**CERTIFICATE OF APPROPRIATENESS**

**Property:** 714 Woodland Street, lot 3, tract 4A, block 36, Woodland Heights Subdivision. The property includes a historic 2,491 square foot, one and half story wood frame single-family residence situated on a 7,500 square foot (75' x 100') interior lot.

**Proposal:** Alteration – Replace the existing porch shed roof with a new shed roof to match the existing shed roof and replace four non-original square wood porch columns with four 8 ½” square wood columns with 10” square wood bases. Install wood handrails and guardrails. Install three new wood brackets on the front and rear gable dormers and five brackets on the side gables to match the original missing brackets. Install a brick facing on the existing concrete porch.

**Recommendation: Partial Approval:**

NORTH ELEVATION – FRONT FACING WOODLAND STREET

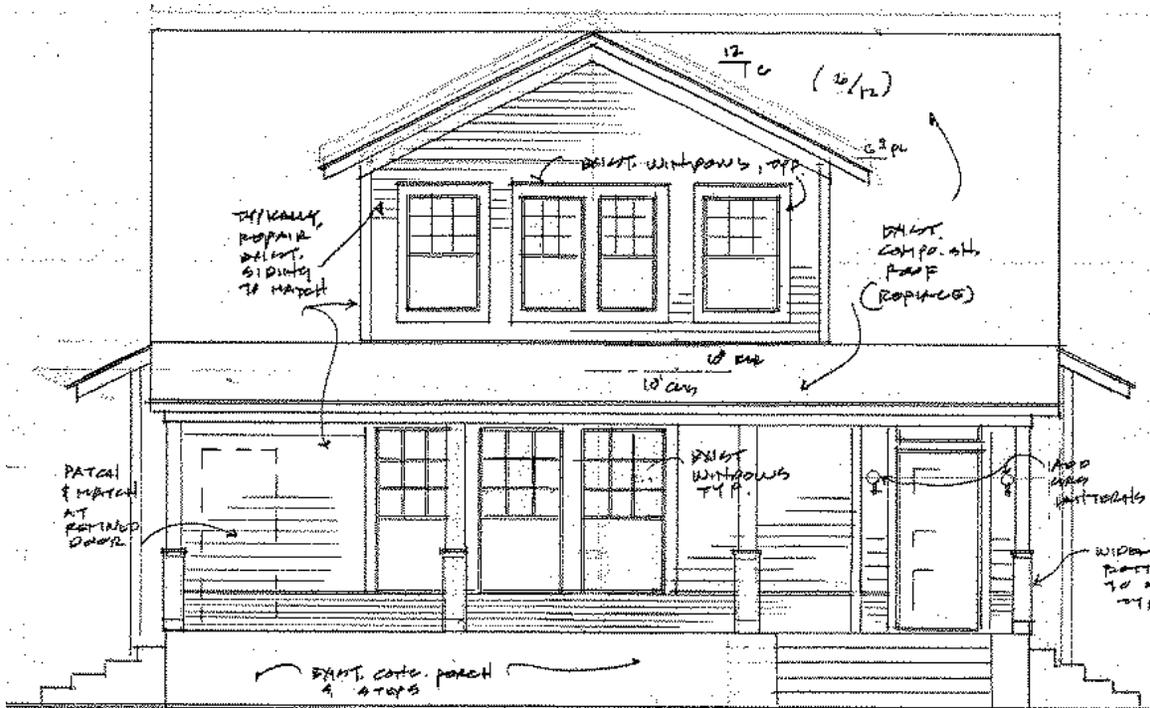
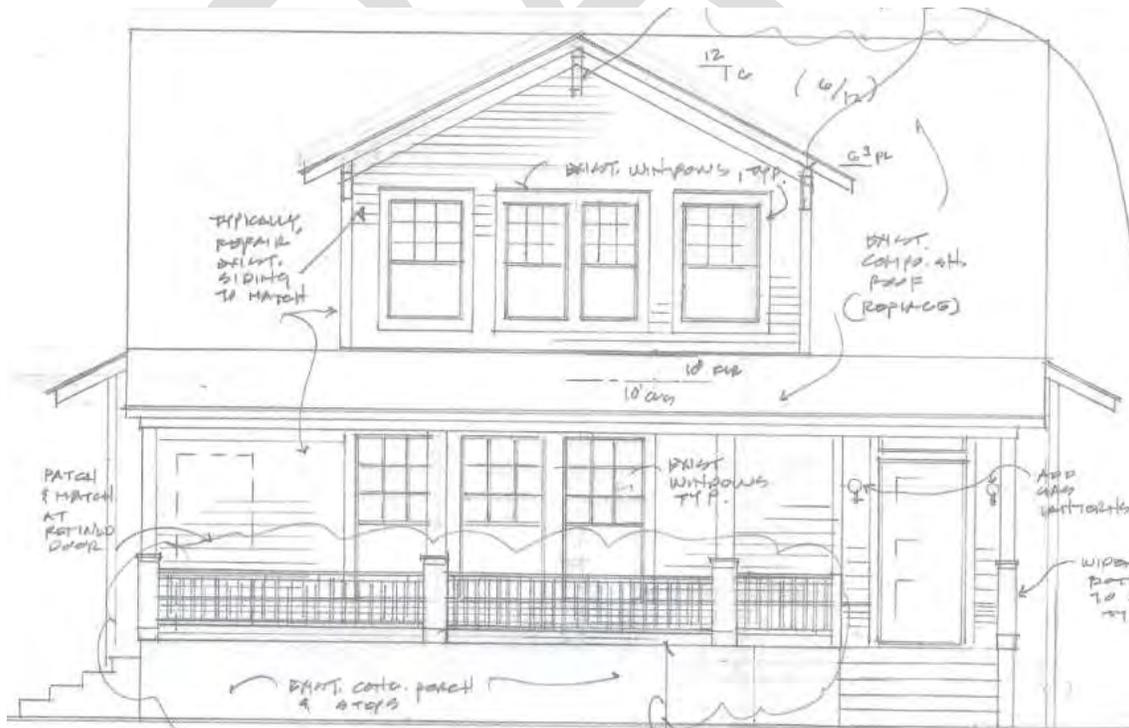
| <input type="checkbox"/>            | <input checked="" type="checkbox"/> | <input type="checkbox"/>            | (3)                  | The proposed activity must recognize the building, structure, object or site as a product of its own time and avoid alterations that seek to create an earlier or later appearance;<br><i>The application of the brick facing to the existing concrete porch creates a false sense of history by introducing an architectural feature that has never been present on the residence.</i>                        |                            |
| <input type="checkbox"/>            | <input checked="" type="checkbox"/> | <input type="checkbox"/>            | (4)                  | The proposed activity must preserve the distinguishing qualities or character of the building, structure, object or site and its environment;<br><i>Brick porches and brick porch facing is not typical of contributing residence in the district. The typical condition found in the district is either wood porch decks with either wood or concrete steps or a concrete porch deck with concrete steps.</i> |                            |

**Deny:** The application of the brick facing to the existing concrete porch deck.
